# The City of Lewes

## STAFF REVIEW

FEBRUARY 21, 2019

<b>Application Title</b>	Lewes Waterfront Preserve
<b>Application Type</b>	Preliminary Consent - Major Subdivision
<b>Owner</b>	7-11 Market Inc.
<b>Equitable Owner</b>	Setting Properties, Inc.
<b>Tax Map and Parcel</b>	335-8.00-17.00
<b>Size and Location</b>	34.64 acres
<b>Comprehensive Plan Designation</b>	Residential
<b>Zoning District</b>	AX-RES Annexation Residential (Cluster Option 2)
<b>Present Use</b>	agriculture
<b>Proposed Use</b>	residential dwellings and permanent open space
<b>Online application material</b>	<a href="https://lewescommissions.wordpress.com/reviews/dev_reviews/lewes-waterfront-preserve/">https://lewescommissions.wordpress.com/reviews/dev_reviews/lewes-waterfront-preserve/</a>

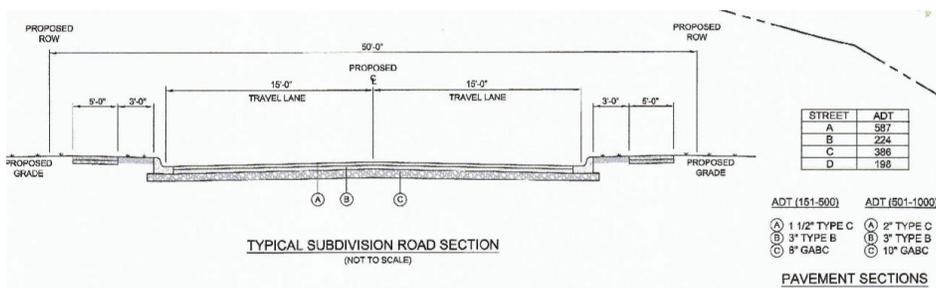
According to information provided with the application vehicle access will be provided using a proposed internal road network with access from New Rd., adjacent to Creekside Drive. The applicant is proposing to build the new roads to City standards using a 50' ROW comprised of 2 travel lanes (15' lanes), with curbs/gutters and 5' sidewalks on each side along with 3' unpaved section between the sidewalks and curbs (see typical roadway section below). The

Commented [TW1]: Please verify

proposed streets will be offered for dedication to the City and would be maintained as public streets. Based on the submitted plan the development will contain a total of 204 parking spaces, 180 would be on lot spaces and 24 would be overflow spaces that are located off of the internal roads. The applicant also provided a breakdown (by road segment) of anticipated average daily trips (ADT) based on the number of proposed dwelling units. Additional details on the internal road network can be found in the City's Engineer Report for the proposed subdivision.

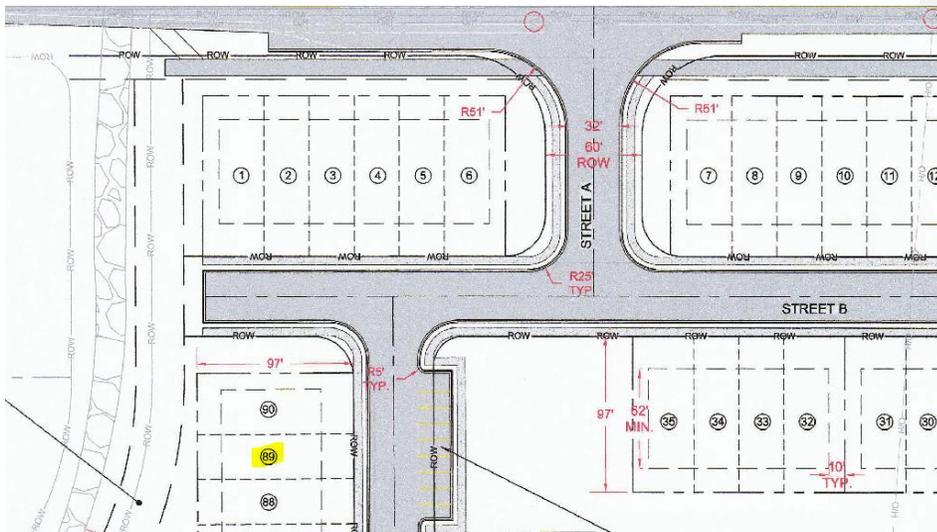
As noted by the State Historic Preservation Office (SHPO) as part of the State PLUS review, the parcel contains an identified archeological site, the Derrickson Site. During the PLUS review it was noted that the probable location of the site was in the northeast portion of the tract which is to remain as protected open space, it was mentioned that detailed information from an earlier assessment was not available. Although it is possible the Derrickson Site is included in the open space area, the applicant should continue working with the SHPO to determine the recommended methods for investigating the status of the site and a possible archaeological survey of the parcel. Results from the investigation should be provided to the City so that the information can be factored into any final development decisions.
